# NWRL EIS 2 SUBMISSION

BY THE GPT GROUP

December 2012

$\label{thm:cond} \mbox{Figure 16.23} \quad \mbox{Rouse Hill Station from Windsor Road - after development (showing general form and scale of development only) }$

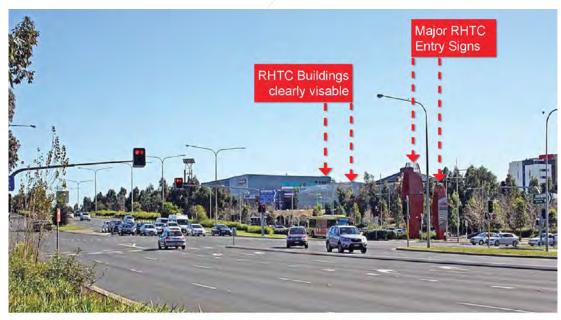
There is a risk that the viaduct and station building will make RHTC virtually invisible from Windsor Road. GPT submits that this could have significant commercial ramifications and mitigating measures are required.

39. That the Minister require a Signage Strategy to be agreed between TfNSW, RMS and GPT to ensure that appropriate Site/Business Identification Signage, and directional and wayfinding signage is able to be erected on land within the rail corridor and/or road reserve.
